Re: Site Plan Review application submitted by Bohler Engineering on behalf of Chick-fil-A to construct a new $\pm 5,200$ square foot fast food restaurant with drive-thru at 65 Mount Auburn Avenue (Tax Map 280, Lot 006.1). The property is located in the General Business (GB) zoning district and will be reviewed under Chapter 60, Article XVI, Division 2 – Site Plan Review and Division 3 – Special Exception.

Date: July 08, 2025

Re: Response to Comments Major Site Plan Review Chick-fil-A 65 Mount Auburn Avenue

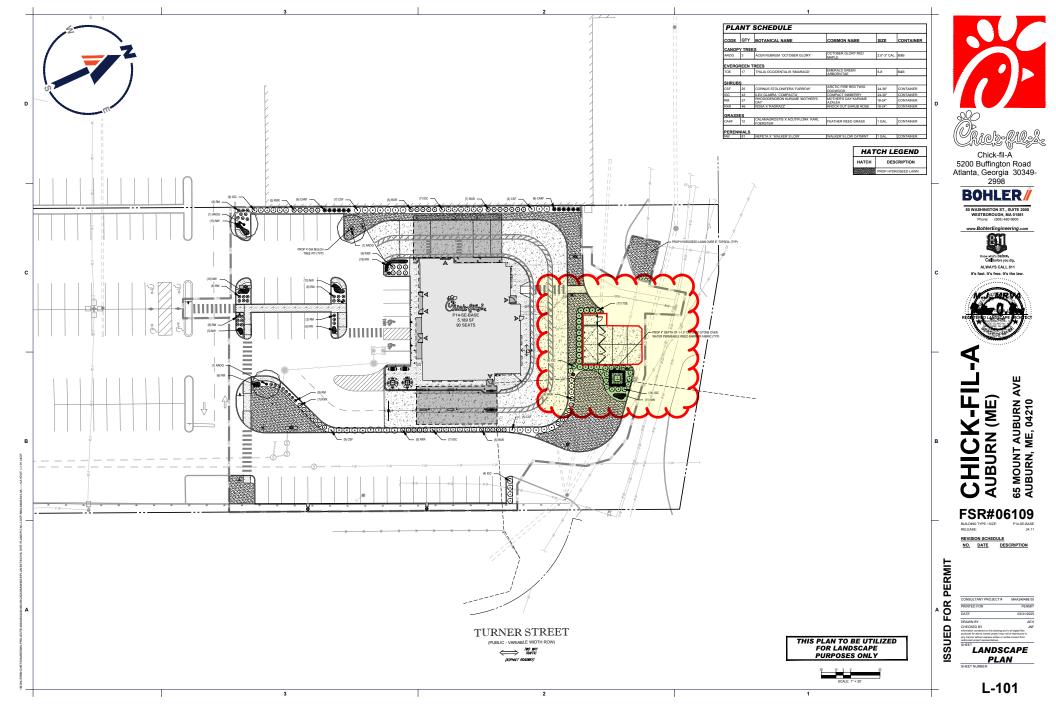
- Fire Department Review
- *Comment*: We are currently waiting for final feedback from the Fire Department. In the meantime, we recommend adding:

- A fire truck turning radius template

-Labeling of the nearest hydrant(s) and confirmation of compliance with Fire Code access and spacing

Response: Per the email received on 6/25 from your office, "The Fire Department is okay with what was previously submitted; you do not need to do the things on my list labeled "fire department." Comment acknowledged.
